Technical Service Bulletin

26 Noises are heard from the exhaust system at idle speed

26 20 39 2058998/1 March 24, 2020.

Model(s)	Year	VIN Range	Vehicle-Specific Equipment
RS4, RS5	2018 - 2019	All	Not Applicable

Figure 1. Old rear silencer.

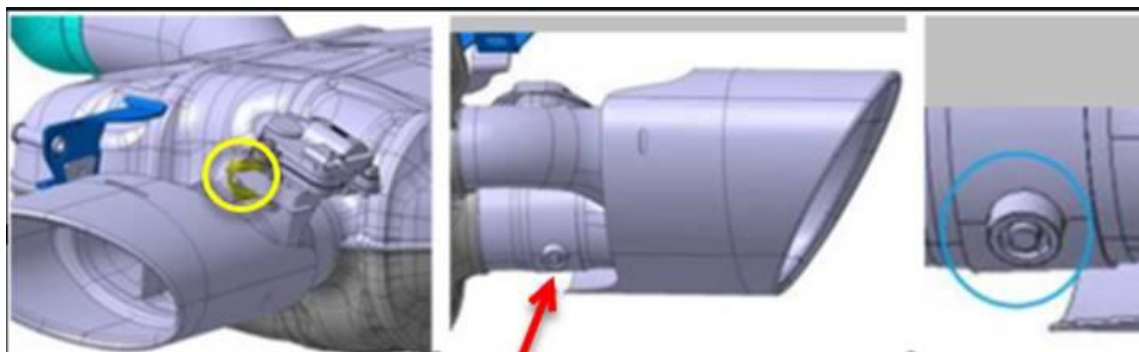
- A. Old version: C-bar (marked yellow) and floating bearing (blue). **It is not compatible with an optimized control motor.** The complete rear silencer has to be replaced.

Figure 2. The optimized version of the rear silencer.

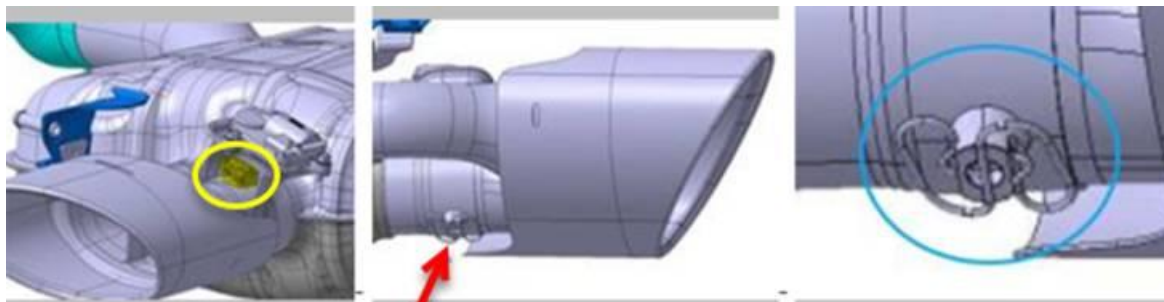
- B. Optimized version: claw coupling (marked yellow) with spring lock (blue). Check which version of the control motor is fitted: If a new control motor (part number 8S0 133 246 D) has not yet been installed, replace it individually on the exhaust flap with the concern.
